Appliance Standards Awareness Project  
American Council for an Energy-Efficient Economy  
National Consumer Law Center  
Natural Resources Defense Council  
Northwest Energy Efficiency Alliance  
Northwest Power and Conservation Council

October 21, 2013

**RE: Docket Number EERE–2009–BT–STD–0018/ RIN 1904–AC00: Notice of Proposed Rulemaking for Metal Halide Lamp Fixtures**

**Figure 1. Ballast Replacement Schedule Assumed in the NOPR for Indoor and Outdoor Fixtures.**

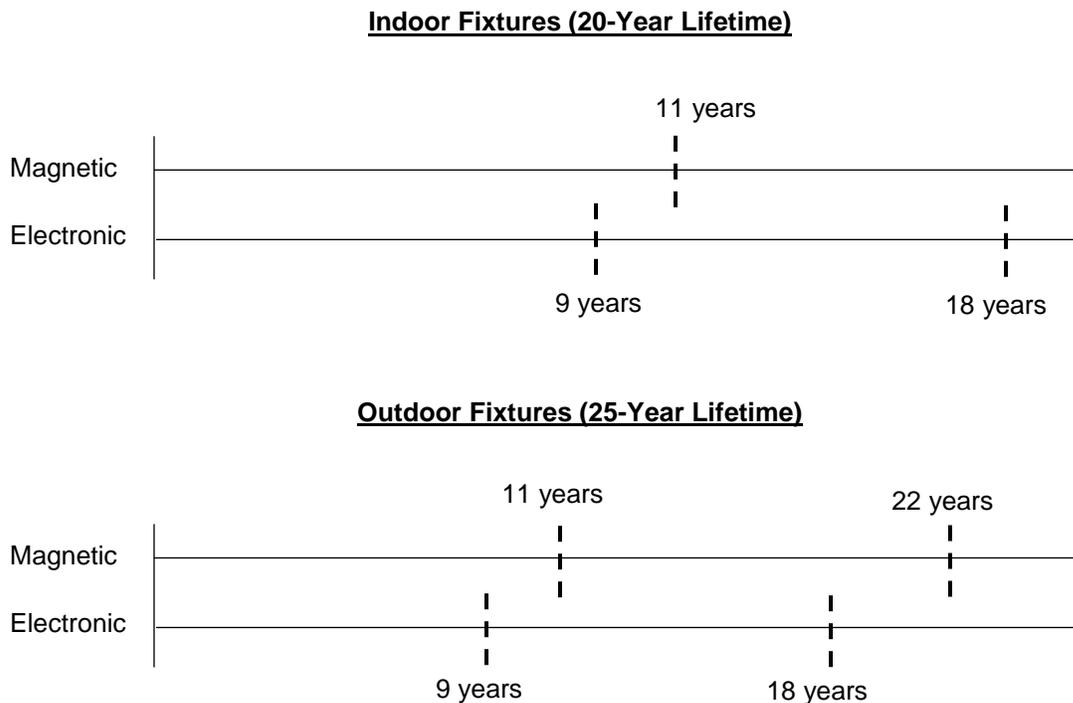
We do not believe that it is realistic to assume that a fixture is replaced at the end of its assumed lifetime regardless of when the fixture's current ballast was installed. For example, for indoor fixtures with electronic ballasts, it seems unlikely that a customer would conduct a second ballast replacement after 18 years, and then replace the entire fixture just two years later even though 7 years of the ballast's lifetime remain. Similarly, for outdoor fixtures with magnetic ballasts, it seems unlikely that a customer would conduct a second ballast replacement after 22 years, and then replace the entire fixture just three years later even though 8 years of the ballast's lifetime remain. Instead, it seems likely that a customer would either replace the entire fixture earlier than

its assumed lifetime (e.g. after 18 years in the case of indoor fixtures with electronic ballasts) or extend the life of the fixture given the significant cost of replacing a ballast. Table 1 below shows that the total cost of replacing a 250W ballast for an indoor fixture (including installation costs) at both the baseline and “max-tech” levels is roughly 40% of the total cost of installing a new fixture.

We understand that it would be difficult to capture all the possible customer responses to ballast failures in the analysis. However, DOE’s current approach is not a reasonable approximation, and, as a result, DOE’s analysis understates the cost-effectiveness of electronic ballasts in indoor applications. We suggest that DOE take one of two approaches to better reflect what we believe to be more likely customer responses to ballast failures. The first approach would be to use a distribution of fixture lifetimes. In other rulemakings, DOE has typically used distributions of product lifetimes for the lifecycle cost analyses, while in this rulemaking, we understand that DOE has used single values for indoor and outdoor fixture lifetimes of 20 and 25 years, respectively.<sup>9</sup> In the case of indoor fixtures with electronic ballasts, for example, using a distribution of fixture lifetimes would reflect that in some cases, the fixture lifetime would be shorter than 18 years, which would mean that the second ballast replacement would not occur, while in other cases, the fixture lifetime would be longer than 20 years, which would mean that the second ballast replacement would take place many years before the end of the fixture lifetime. The second approach would be to assign a salvage value to ballasts in cases where a ballast has not reached the end of its lifetime when the fixture is assumed to be replaced. With this approach, the salvage value should be based on the total ballast replacement cost (including installation costs). Assigning a salvage value would be a proxy to reflect that customers are unlikely to replace a fixture soon after they replace the fixture’s ballast.

**Figure 2. Efficiency Levels of Magnetic Ballasts in the DOE Compliance Certification Database and Efficiency Levels Analyzed for the NOPR.**

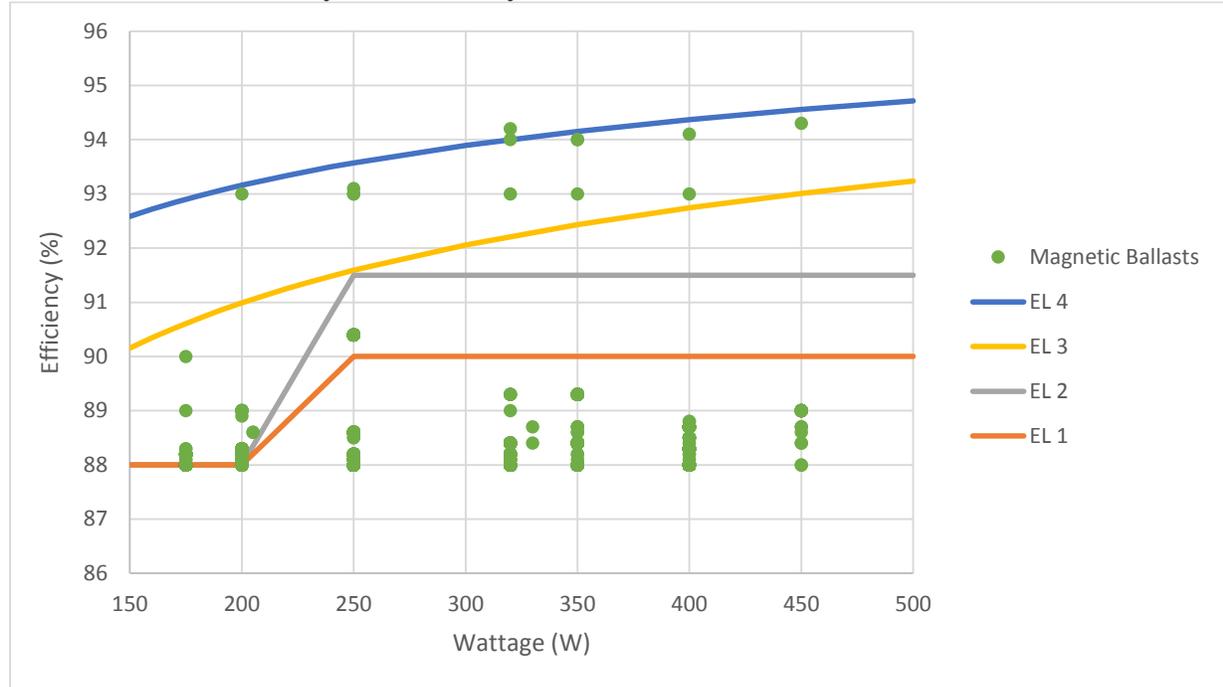
Furthermore, review of the DOE Compliance Certification Database (CCD) and manufacturer product literature indicates that there are single-voltage (277V) linear reactor magnetic ballasts for pulse-start metal halide lamps that exceed EL 2 across a wide range of wattages. (We note that DOE determined that 277V is the most common voltage for ballasts at and above 150W.<sup>22</sup>) Figure 2 below shows the metal halide ballasts in the CCD that are clearly identified as magnetic ballasts.<sup>23</sup> Of these, there are 13 magnetic ballasts that both significantly exceed EL 2, which represents "max-tech" magnetic ballasts, and also exceed EL 3, which represents baseline electronic ballasts. Two of these magnetic ballasts even meet EL 4, which represents "max-tech" electronic ballasts. There are also 175W and 200W magnetic ballasts that exceed EL 2. (See Appendix A for detailed information on these high-efficiency magnetic ballasts.)

We recognize that there are limitations to the use of reactor ballasts, particularly in heavy use environments and over long wiring runs. However, these ballasts represent a high-efficiency magnetic alternative to electronic ballasts for many applications.<sup>24</sup> Since linear reactor magnetic ballasts may have a lower up-front cost than electronic ballasts and are appropriate for many applications, DOE should model these ballasts as the equipment selected in many cases when the standard is set at EL 3 or EL 4.
